UN Regulation No. 26 (External projections of passenger cars)

Proposal for the 05 of amendments to UN Regulation No. 26 (External projections of passenger cars)

Submitted by the expert from Germany on behalf of the Task Force on UN Regulation No. 46*

Model A

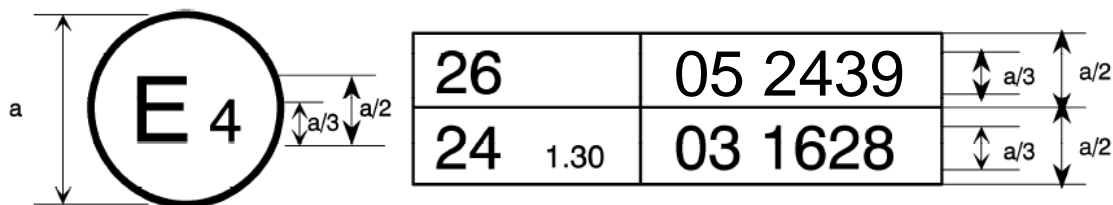
Annex 2, amend to read:

The above approval mark affixed to a vehicle shows that the vehicle type concerned has been approved in the Netherlands (E 4) pursuant to UN Regulation No. 26 and under approval number 052439. The first two digits of the approval number indicate that UN Regulation No. 26 already included the 04 series of amendments when the approval was granted.
